STATE OF NORTH CAROLINA
DEPARTMENT OF TRANSPORTATION

Subject: Modification Request for the Individual Section 404 Permit, Individual Water Quality Certification, and Tar-Pamilico Buffer Authorization for the Rocky Mount Northern Connector, from SR 1604 (Hunter Hill Road) to US 301, Nash County, TIP No. R-2823, Debit \$570 from WBS 34509.1.1.

In an application dated December 17, 2008, the North Carolina Department of Transportation (NCDOT) submitted an Individual Permit application for the Subject project. This application requested authorization for impacts to jurisdictional features based upon a final design prior to an additional public meeting presenting the final design, held on October 28, 2008. Based upon comments from the meeting and subsequent inquiries from the public concerning the traffic flow from Station -L- 27+45 to Station 65+55, the roadway was re-designed to include directional crossovers and four bulb U-turns to provide additional left-turn traffic flow along Woodruff Road. The redesign will result in unavoidable impacts to Waters of the U.S. Revised permit drawings, buffer drawings and roadway plans are included with this modification request.

PROJECT REFERENCE NO.	SHEET NO.
R-2823	7
R/W SHEET NO.	HYDRAULICS ENGINEER
ROADWAY DESIGN ENGINEER	
REVISED 06/11/09 BUFFER DRAWING SHEET 16 OF 56

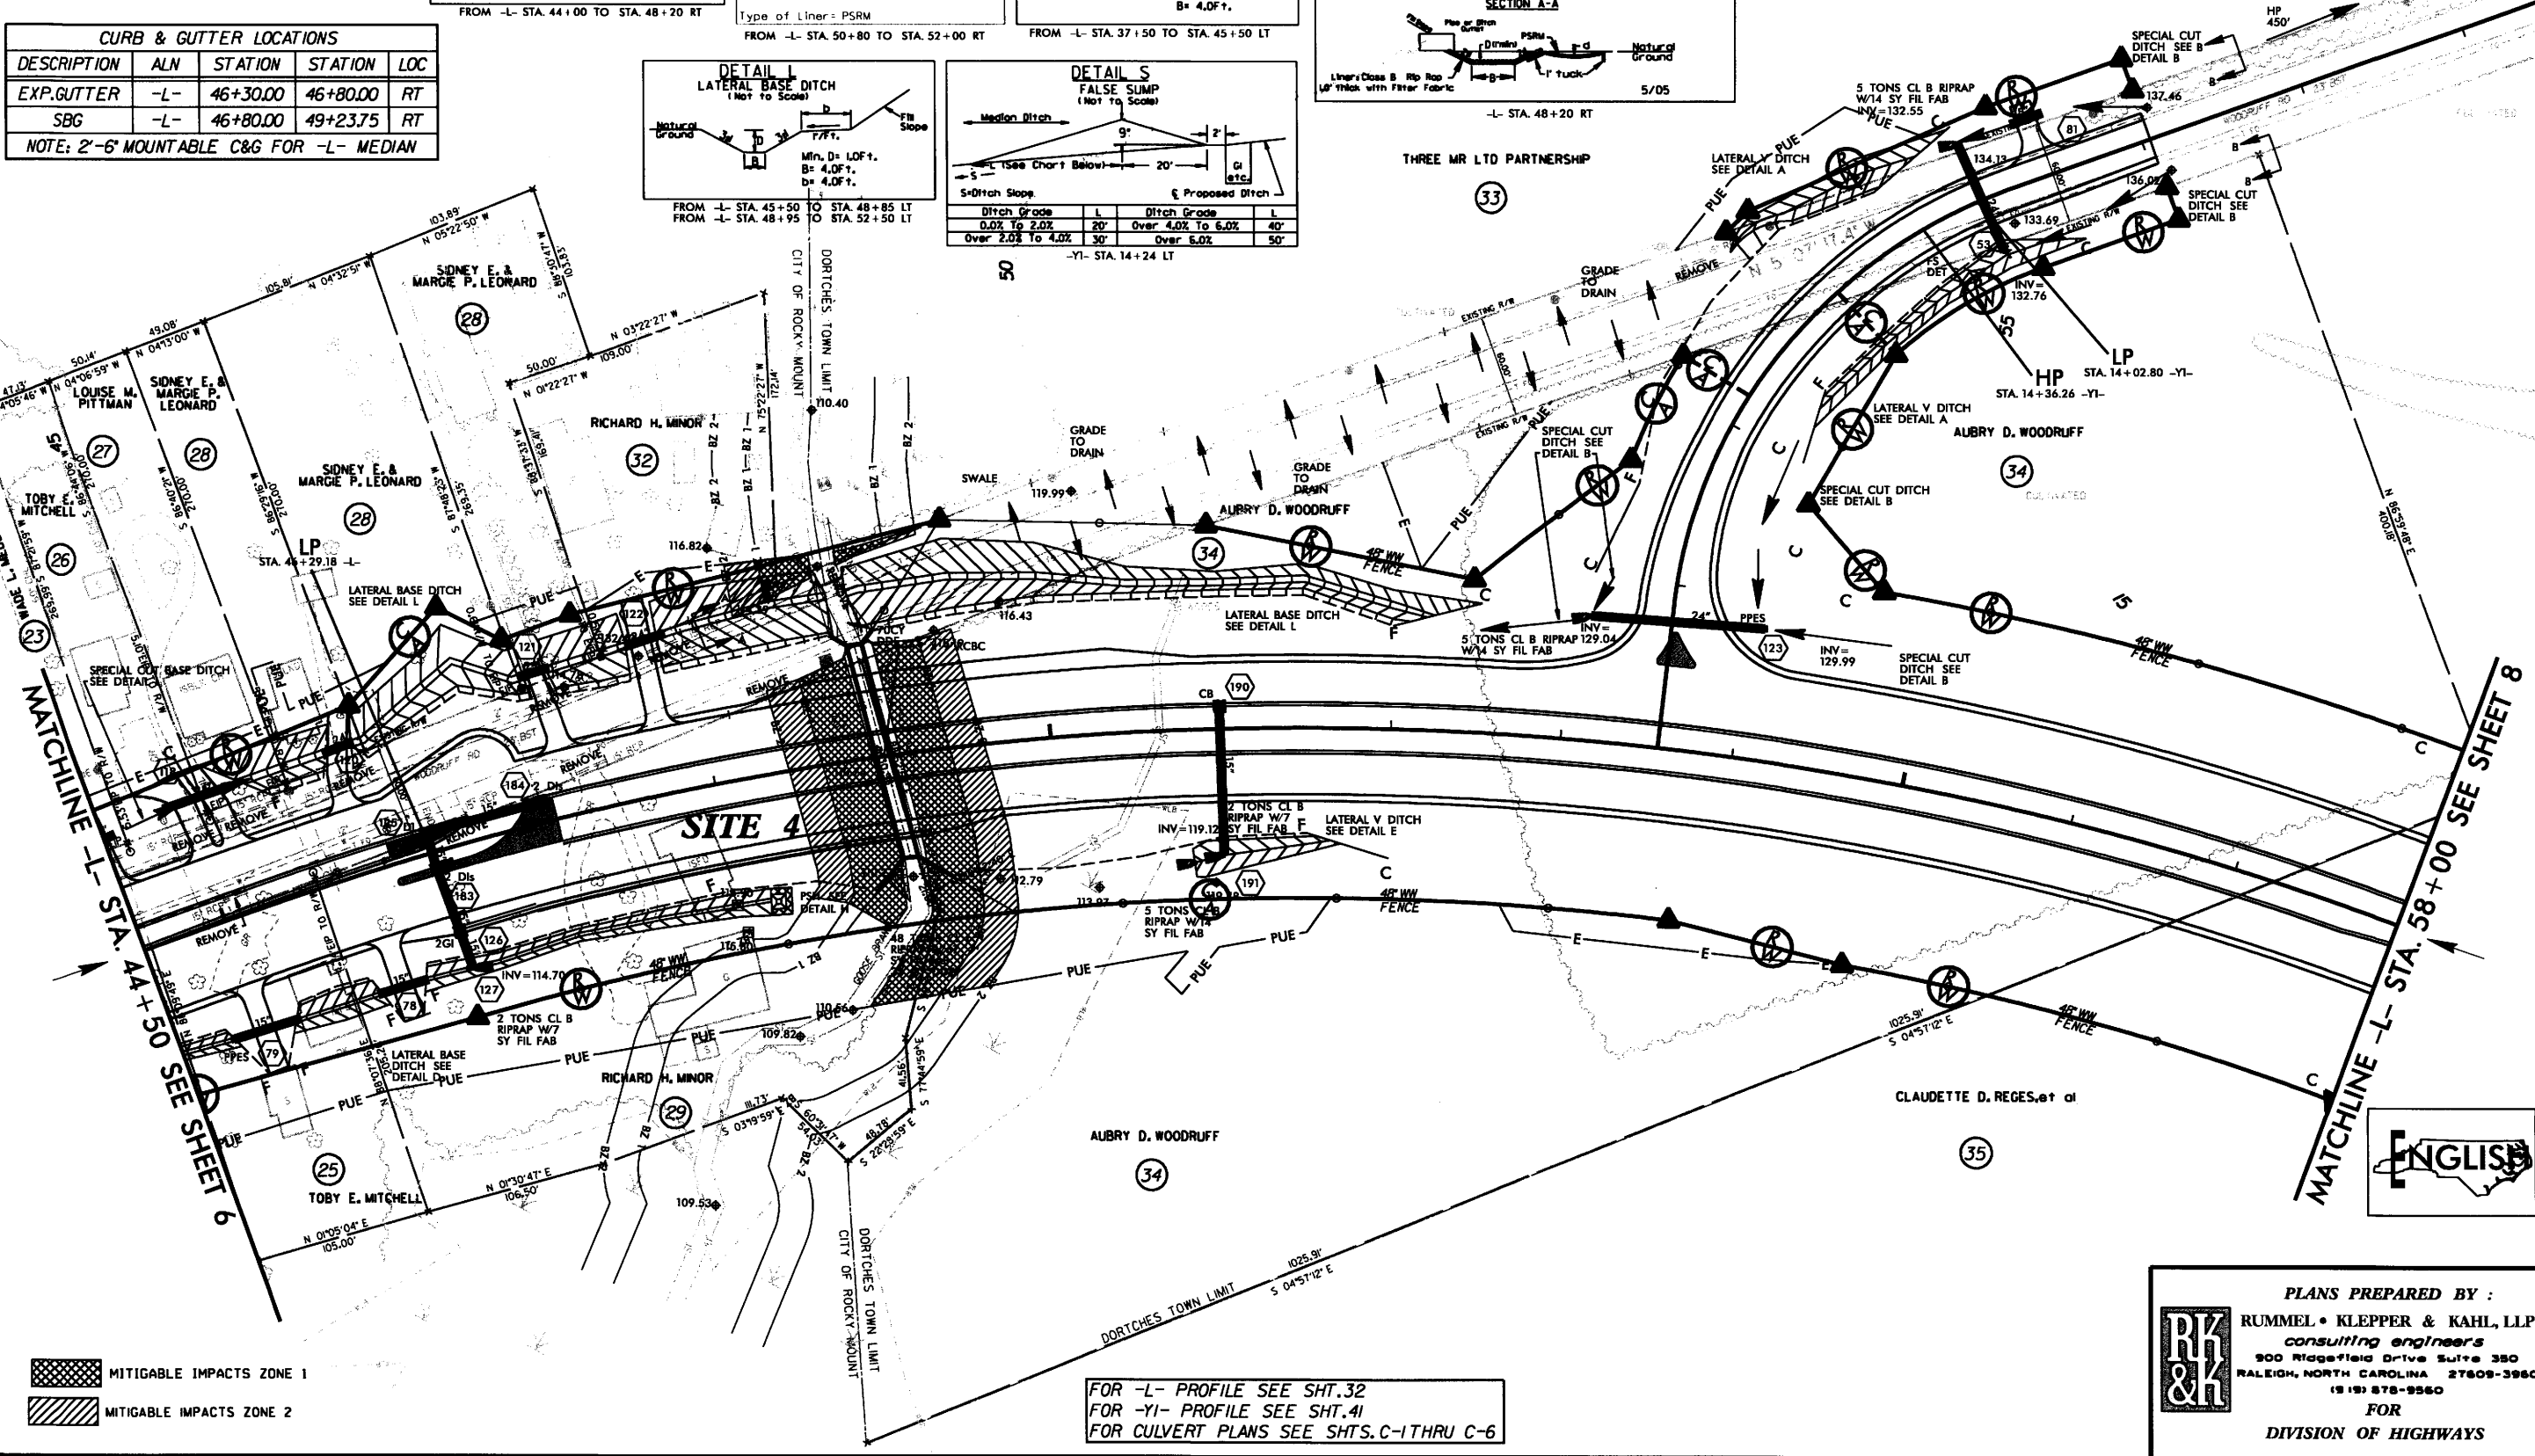
The revised drawings (Permit Sheets 14 and 15 of 68 and Buffer Sheets 15 and 16 of 56) indicate that impacts at Site 4 will change due to aerial utility lines. The sheets have also been revised due to a new bulb which does not have an impact on the environmental features. A summary of the original and revised impacts is provided in the following table.

The revised drawings (Permit Sheets 14 and 15 of 68 and Buffer Sheets 15 and 16 of 56) indicate that impacts at Site 5 will change due to aerial utility lines. The sheets have also been revised due to a new bulb which does not have an impact on the environmental features. A summary of the original and revised impacts at Site 5 is provided in the following table.

Impact Description	Dec. 17, 2008 Impact	Revised Impact	Impact Change
Perm. Surface Water Impacts	0.04 Ac (158 LF)	0.04 Ac (158 LF)	None
Temp. Surface Water Impacts	0.01 Ac (54 LF)	0.01 Ac (54 LF)	None
Wetlands in Buffer Zone 1	41 sq ft	168 sq ft	+127 sq ft
Wetlands in Buffer Zone 2	574 sq ft	1,712 sq ft	+1,138 sq ft
Mitigable Buffer Zone 1	10,527 sq ft	11,823 sq ft	+1,296 sq ft
Mitigable Buffer Zone 2	6,437 sq ft	7,647 sq ft	+1,210 sq ft

REVISED 06/11/09
BUFFER DRAWING
SHEET 19 OF 56

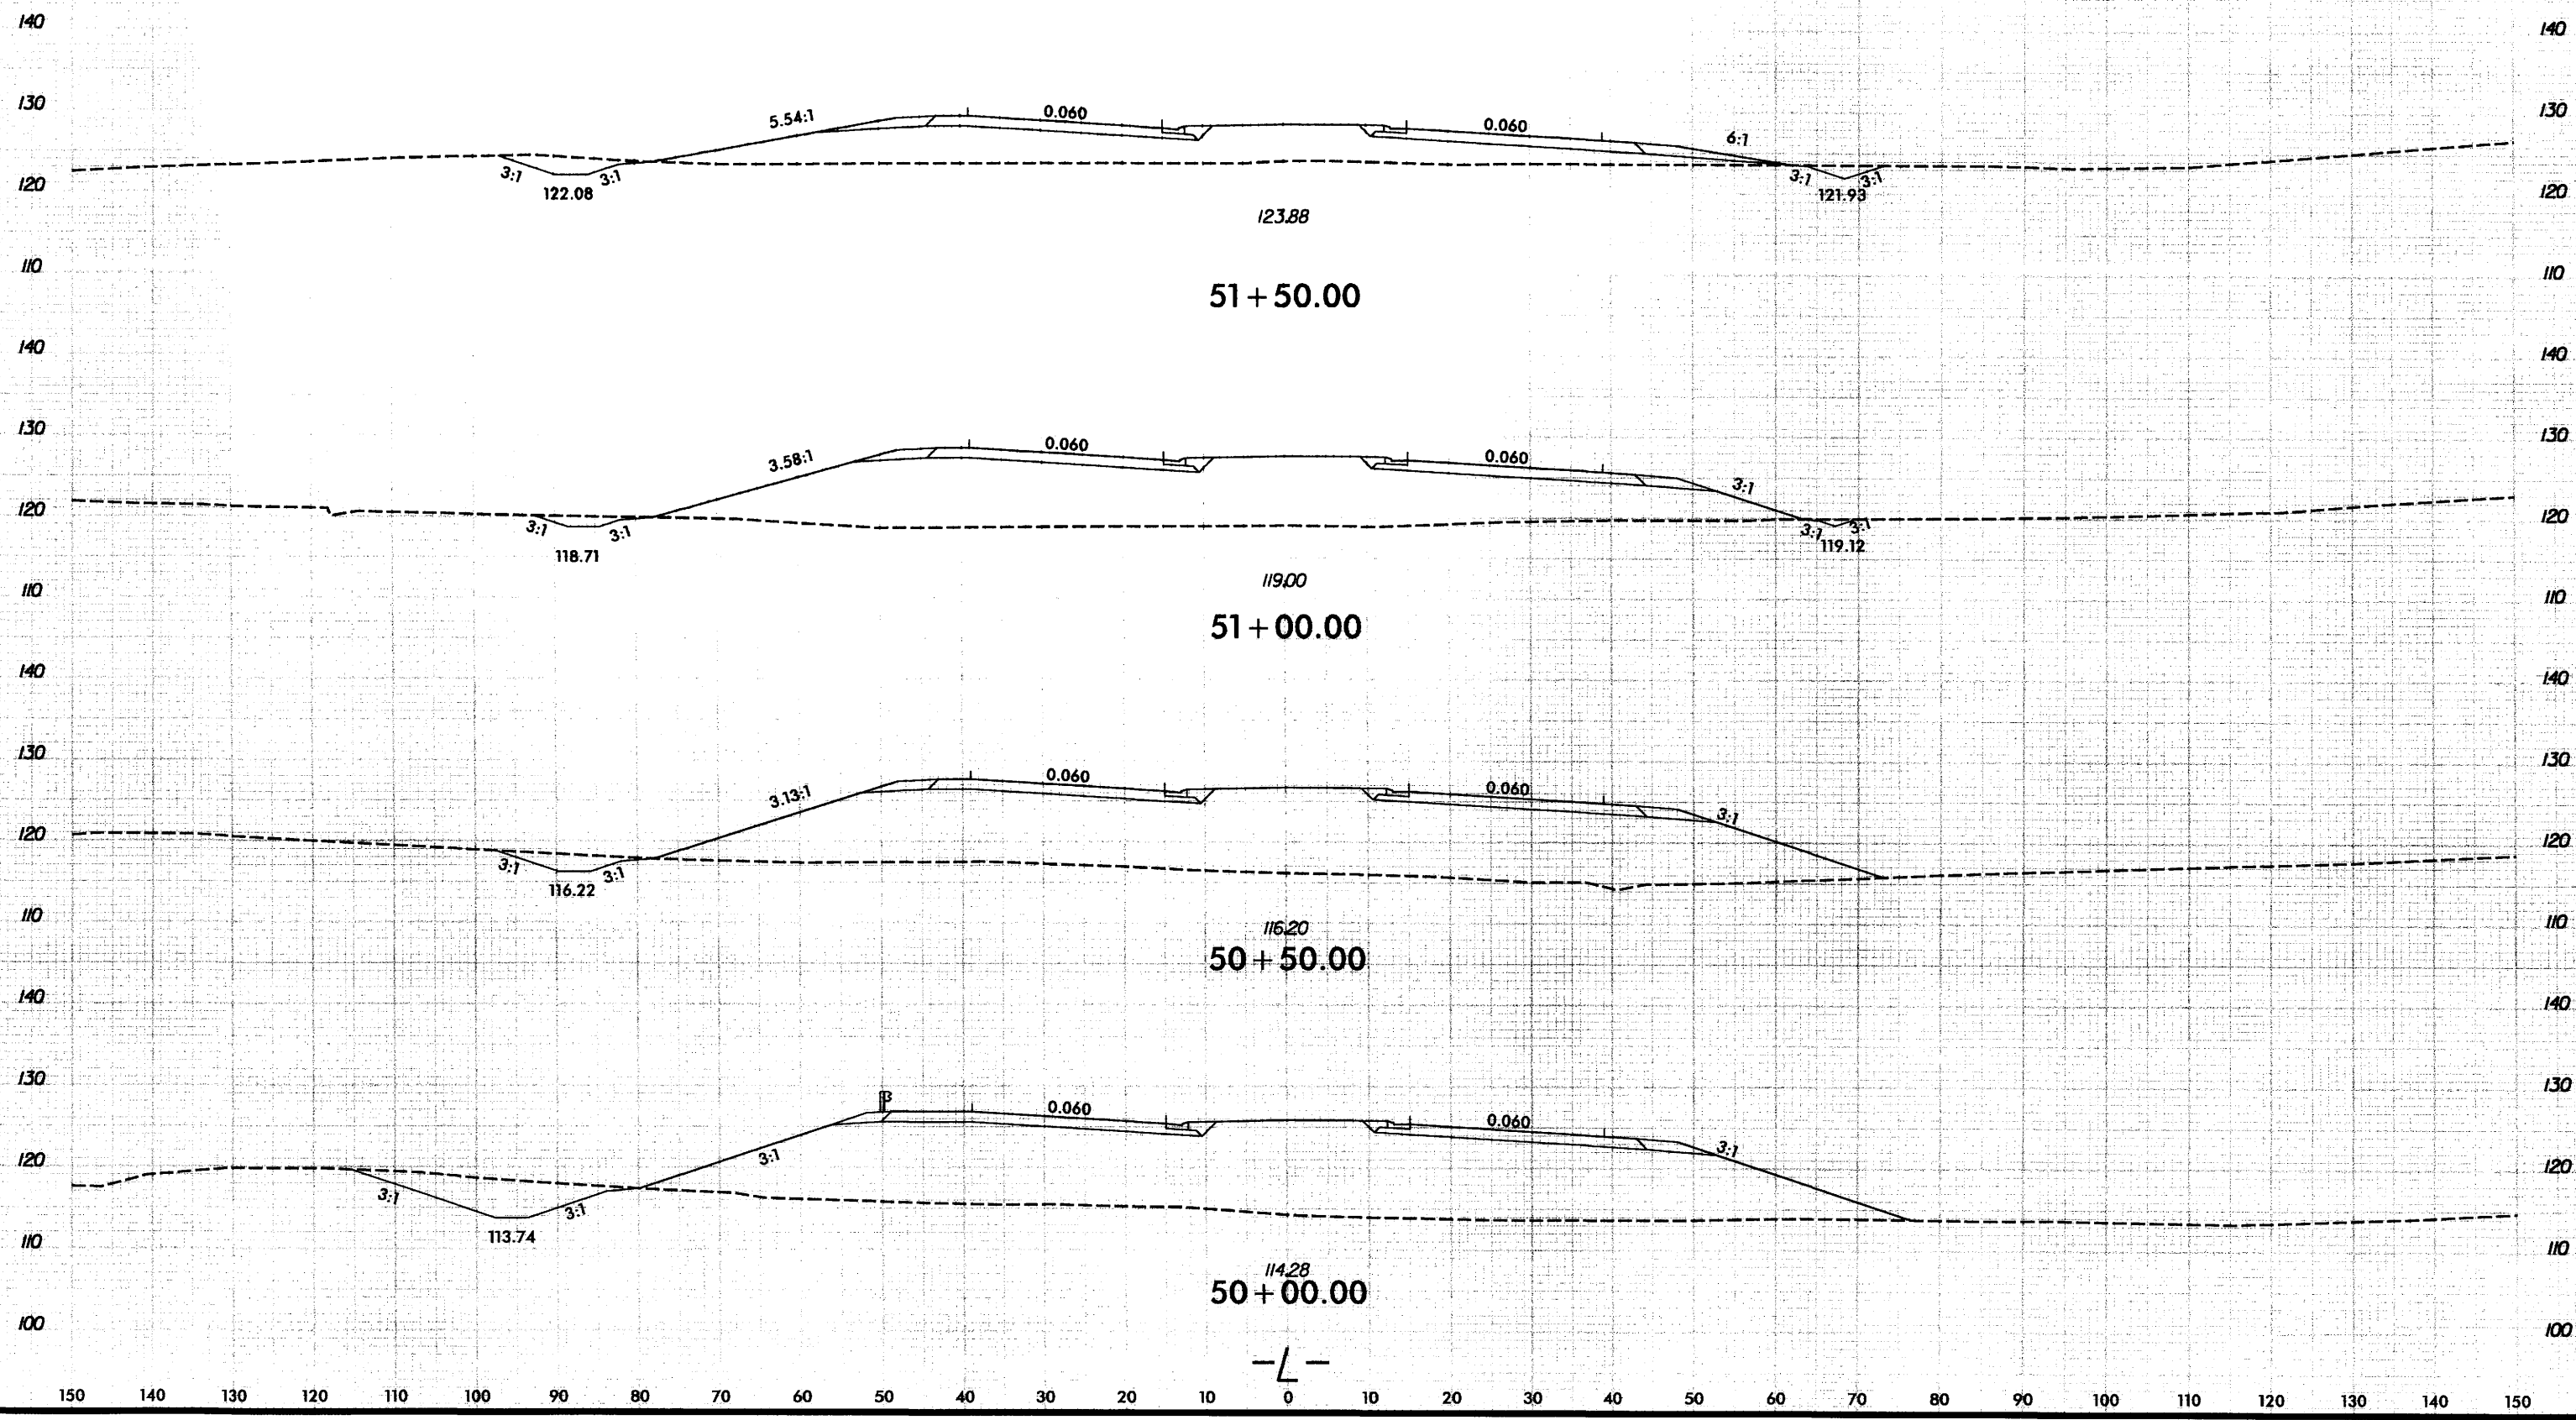
Revised profile and cross section permit sheets 16-18 of 68 (buffer sheets 17-19 of 56) are enclosed.

Revised cross section permit sheets 16-18 of 68 (buffer sheets 17-19 of 56) are enclosed.
